ADDENDUM #2 – APRIL 2, 2025

RE: CITY OF COQUILLE URA
N. Adams Street Improvements Phase 1: Underground Improvements
Project #23.81

FROM: HGE ARCHITECTS, Inc.
333 South 4th Street
Coos Bay, Oregon 97420
541-269-1166

SHEET TITLE:
ELECTRICAL
IMPROVEMENTS

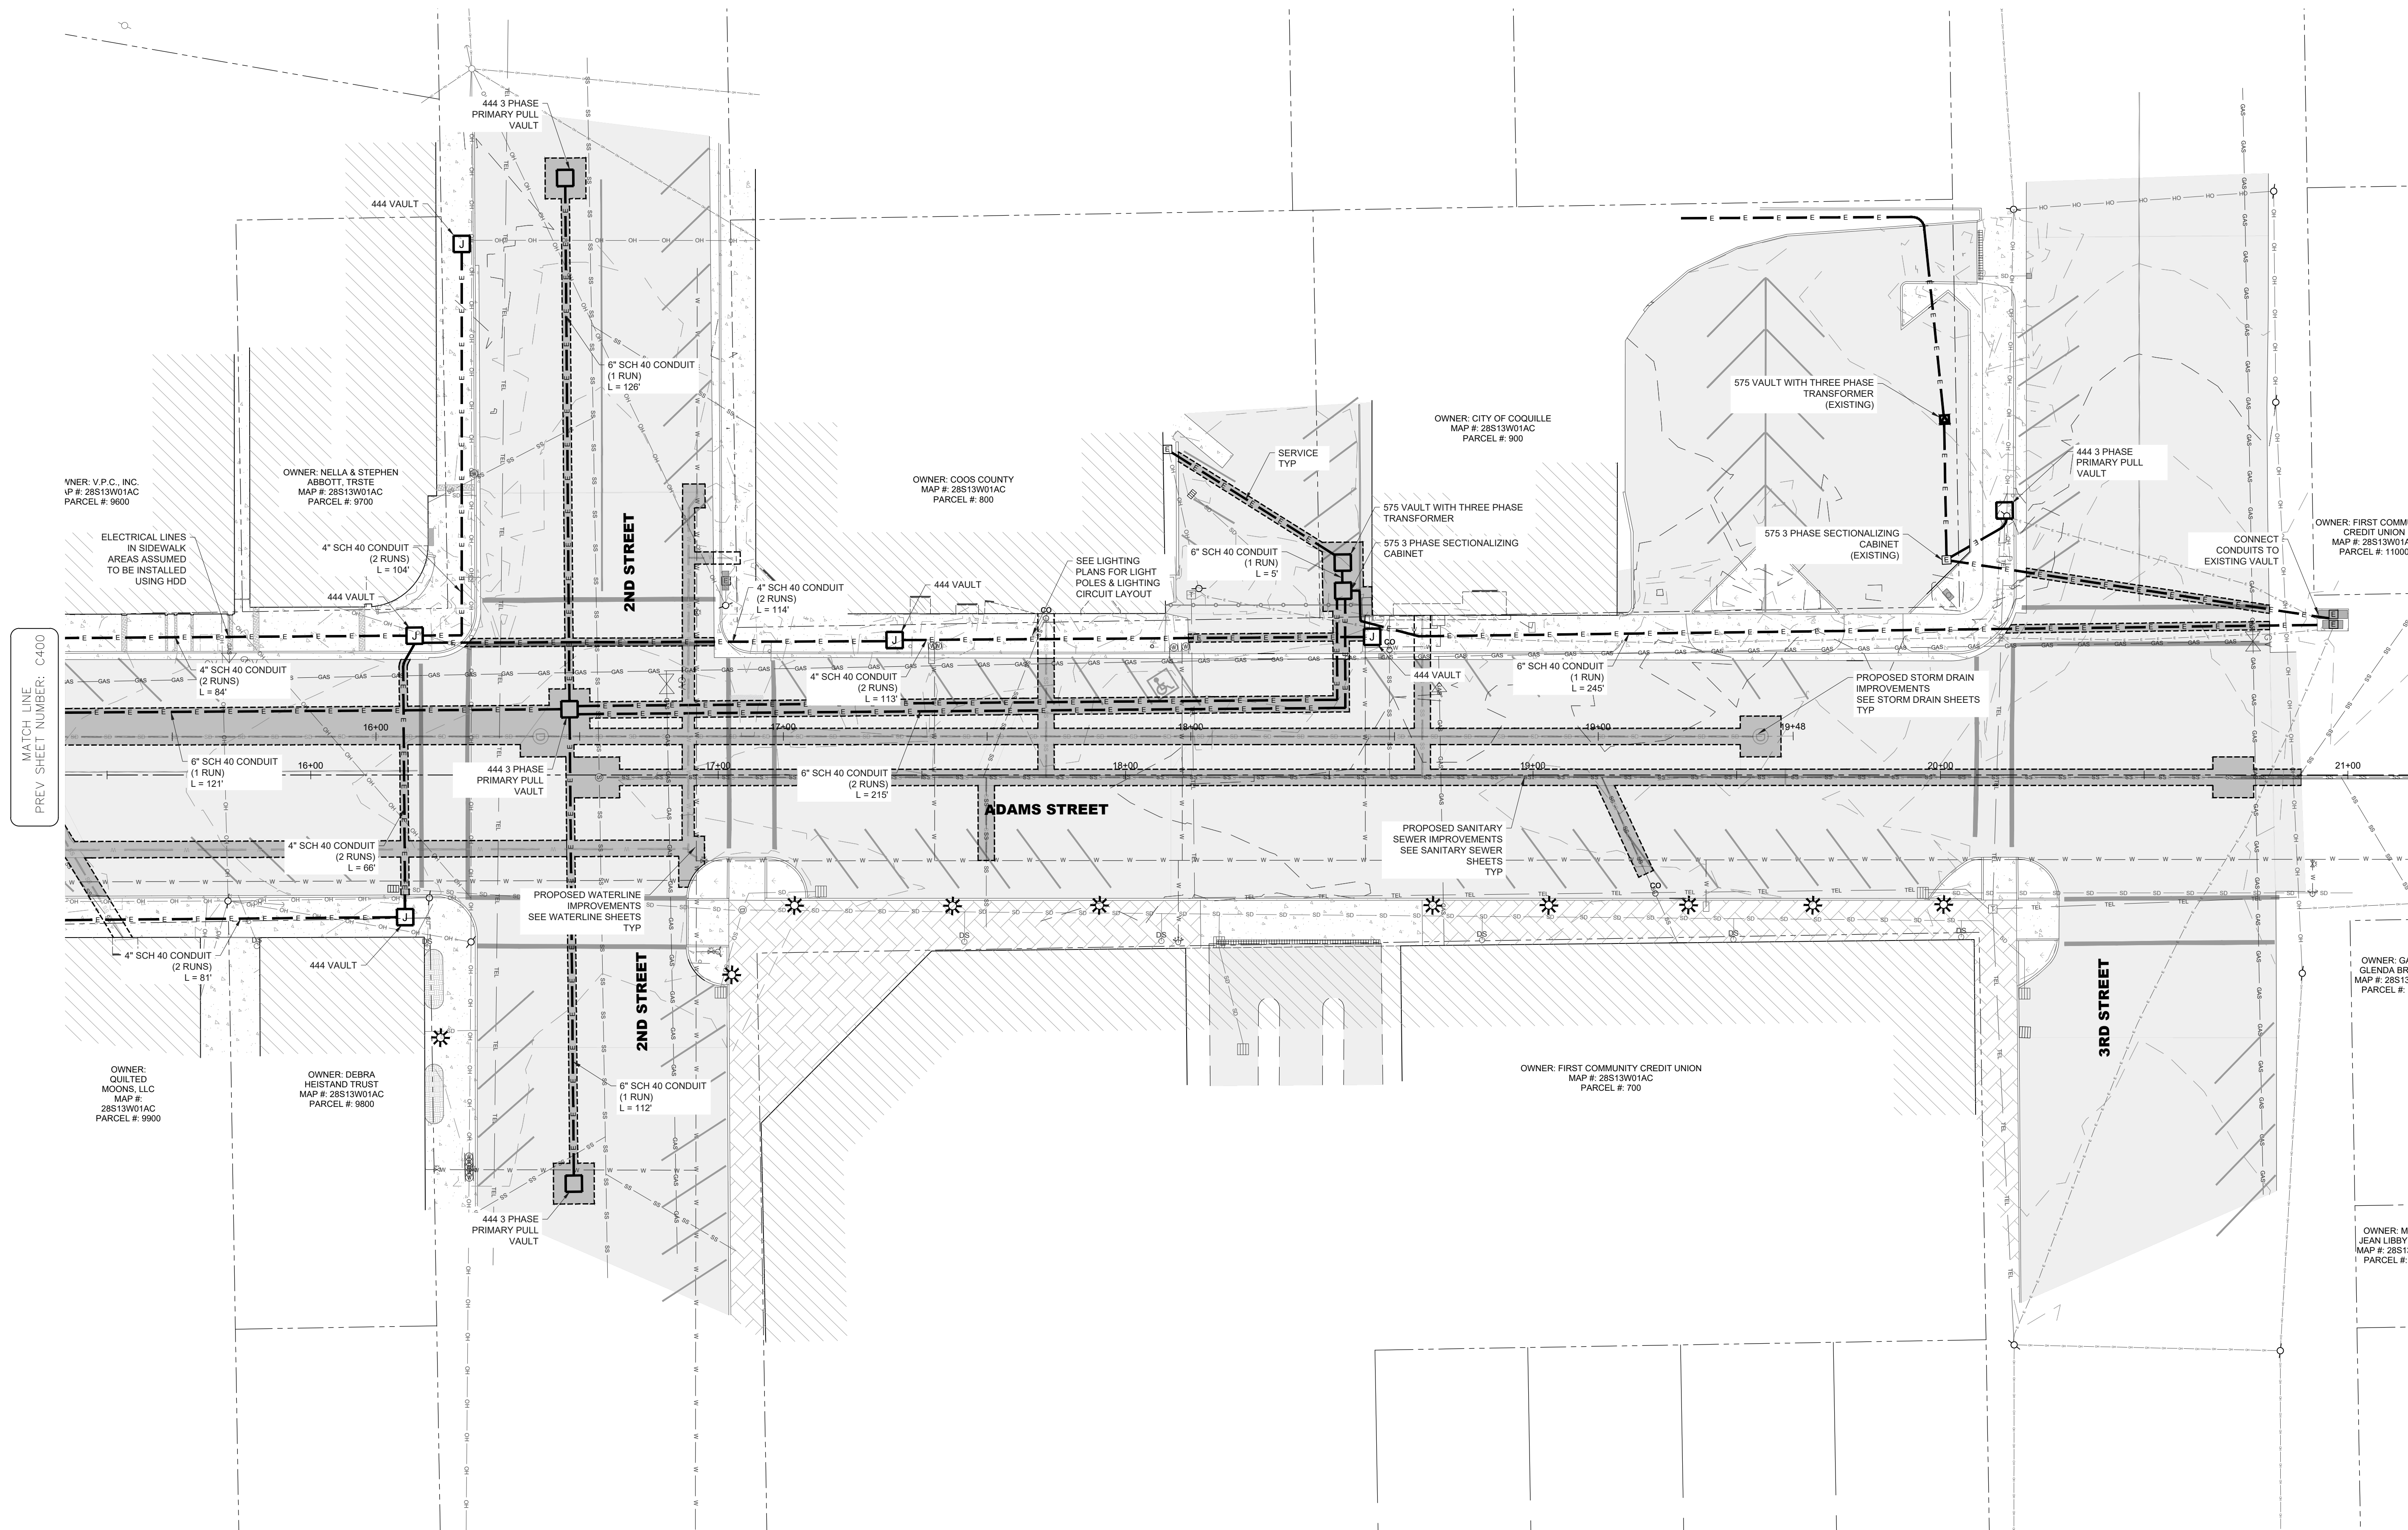
5. **Sheet C401 Electrical Improvements:** REPLACE sheet with attached revised sheet.
 - a. **Revision Summary:**
 - i. Added notes clarifying that the vaults at the Library Parking Lot are existing

- ii. Added notes clarifying the connection to existing vault on the far end of 3rd Street (Project Limits)
